Informal document **GRE-81-16**
(81st GRE, 15–18 April 2019,
agenda item 4)

BOX JUSTIFICATION for GRE-81-13

Poland

Road illumination distance in present Reg. 48

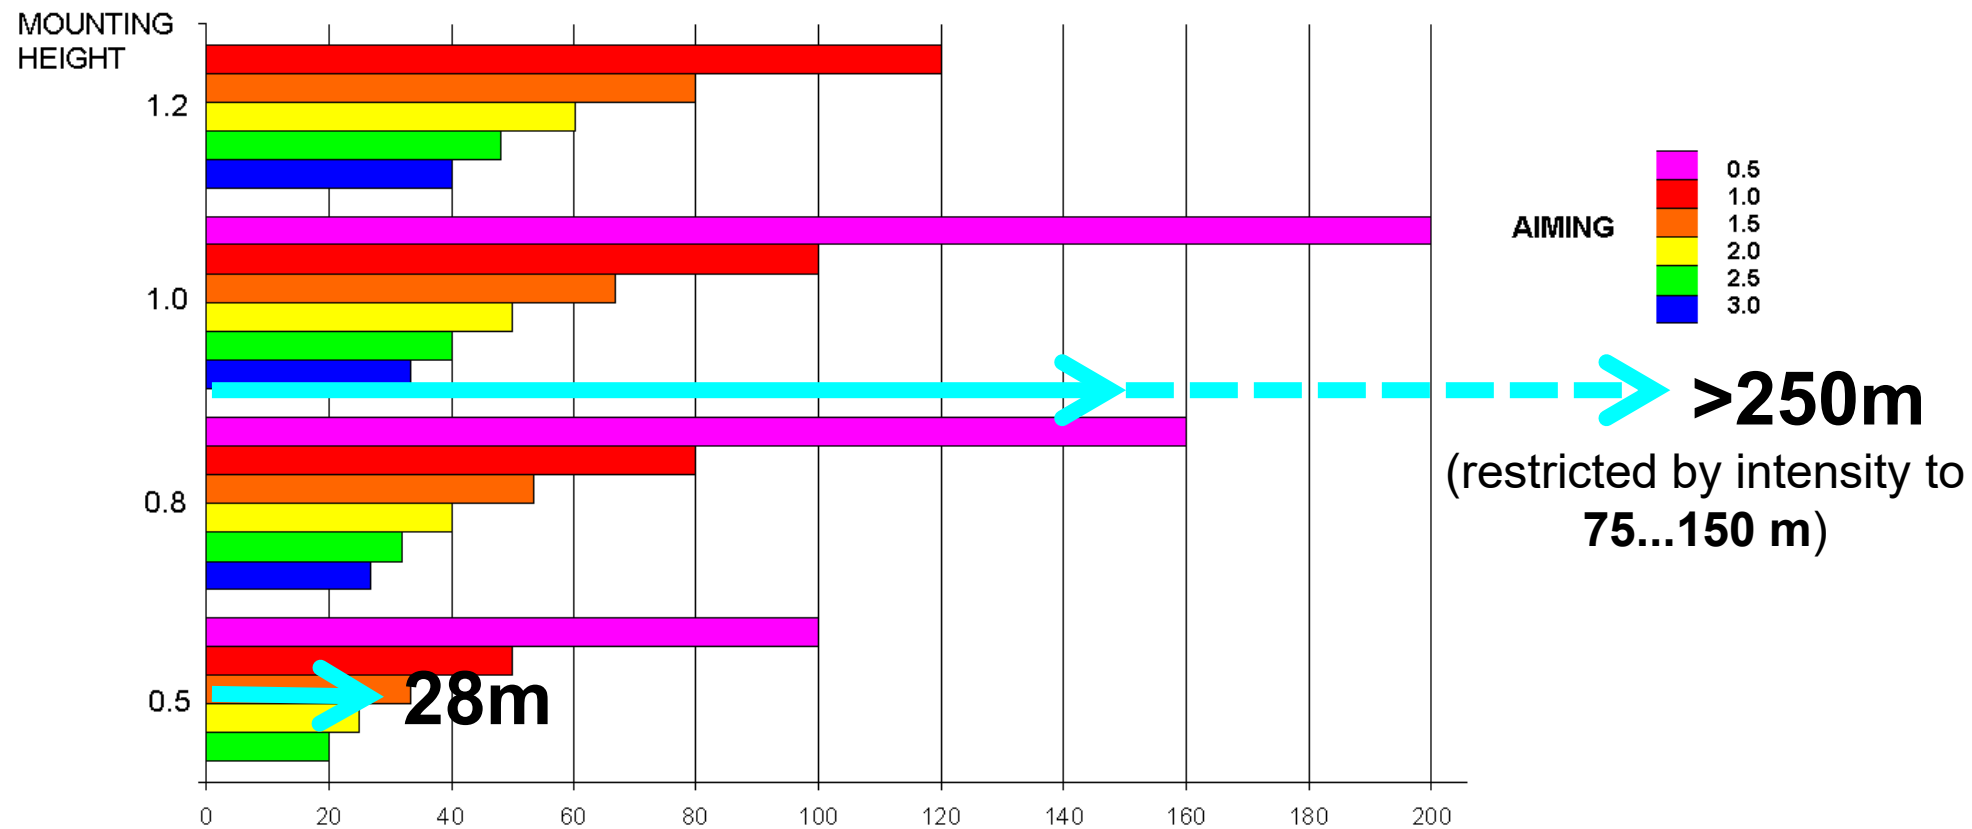
GRE-65-30

Road illumination distance proposed in ECE/TRANS/WP.29/ GRE/2019/3

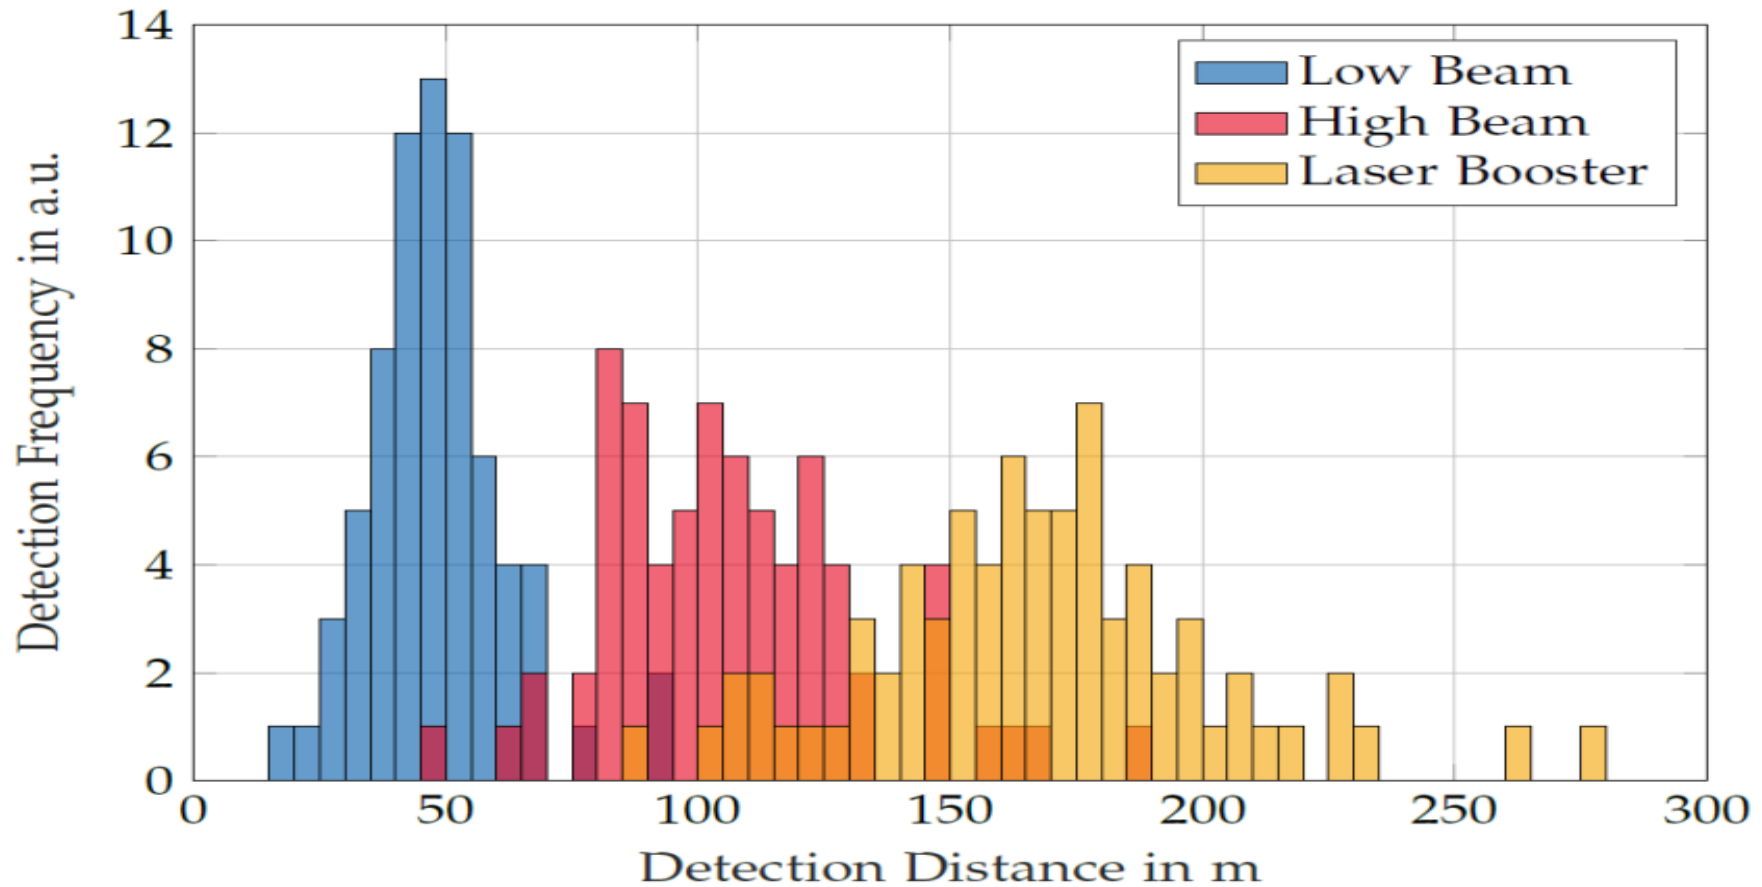
GRE/2019/3

The same glare restriction beyond 25 m

[Min 30 m for special (restricted speed) vehicle]

Min 50m road illumination distance for normal vehicle
